Subject: Duke Energy Carolinas, LLC
William States Lee III Nuclear Station – Docket Nos. 52-018 and 52-019
AP1000 Combined License Application for the William States Lee III Nuclear
Station Units 1 and 2
Supplemental Response to Request for Information (eRAI 6751)
Ltr#: WLG2014.08-02

Enclosure 1
Lee Nuclear Station Units 1 and 2 Supplemental Response
to Request for Additional Information (RAI) Letter No. 108
RAI 08-1 (eRAI 6751)

Subject: SRP Section 08-03 – Stability of Offsite Power Systems

Reference NRC RAI Number(s): 08-1 (eRAI 6751)

Figure 1: Main AC Power Station Simplified One-Line Diagram

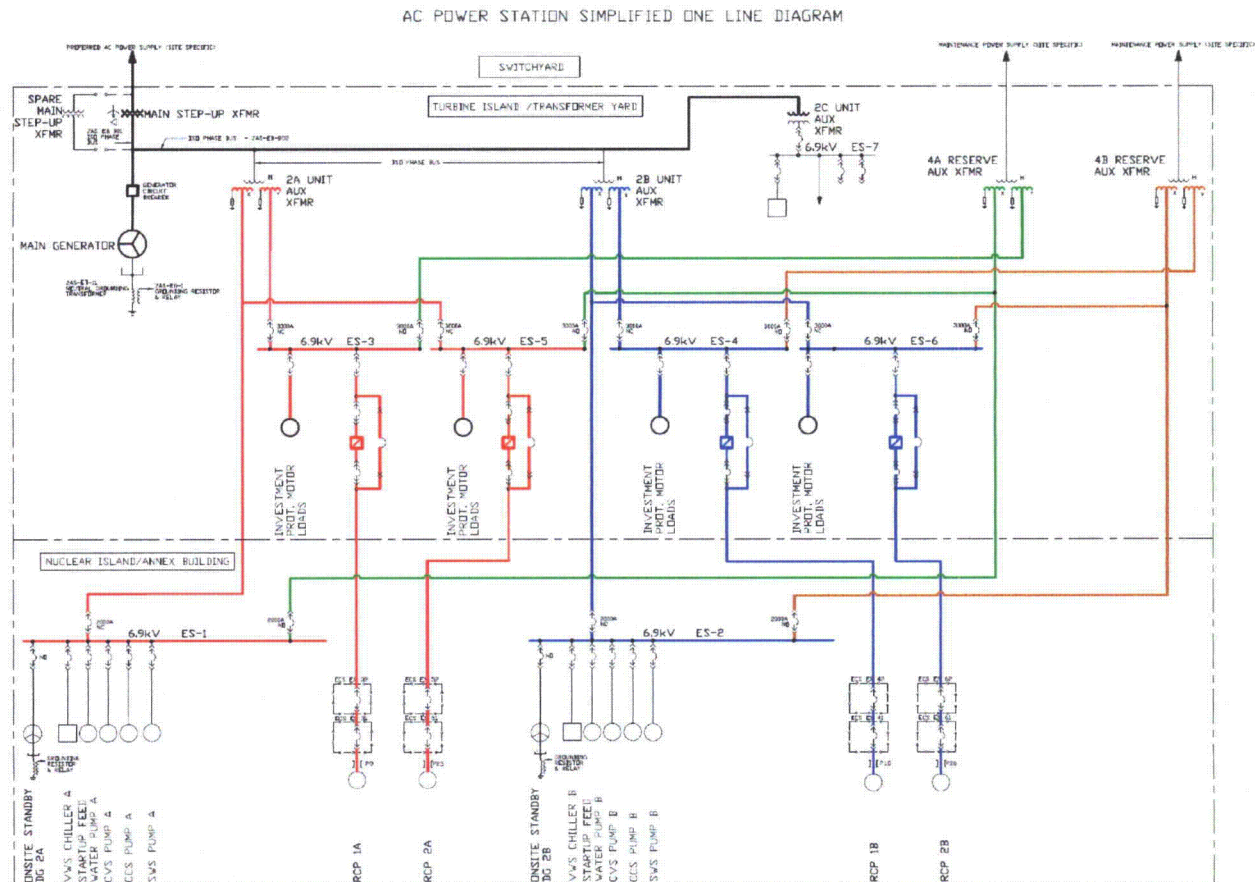
Identify which offsite circuit is credited to meet the GDC 17 requirements, considering the partial exemption for AP1000 plants.

The credited GDC 17 offsite power supply for the AP1000 plant is the Preferred AC Power Supply shown in Figure 1. The Preferred AC Power Supply is backfed through the three single phase main step-up transformers (MSUs), labeled "MAIN STEP-UP XFMR" as shown on Figure 1. The Preferred AC Power Supply is connected to the main generator bus and through the unit auxiliary transformers (UATs) 2A and 2B to the plant electrical distribution system.

Because of its passive safety features, the AP1000 passive plant does not require AC power to place the plant in a safe, stable shutdown condition. The AP1000 design was granted a partial exemption from GDC 17, specifically exempting the AP1000 plant from the requirement for a second GDC 17 credited offsite power source. Therefore, a second credited source of AC power from the power grid is not required. The Onsite Standby Power System (ZOS), powered by onsite standby diesel generators 2A and 2B, provides an alternate source of AC power to the plant electrical distribution system through medium voltage buses ES-1 and ES-2 for defense-in-depth shutdown loads.

Because of the partial GDC 17 exemption, the Maintenance Power Supply, fed through reserve auxiliary transformers (RATs) 4A and 4B, is not considered a credited GDC 17 power source. However, the medium voltage buses ES-1 and ES-2 can be manually aligned to receive power through the RATs. The medium voltage buses will automatically transfer from the UATs to the RATs in the event the credited Preferred AC Power Supply becomes unavailable due to an

electrical fault at either the MSU, the isophase bus, the UATs or the 6.9 kV nonsegregated bus duct.
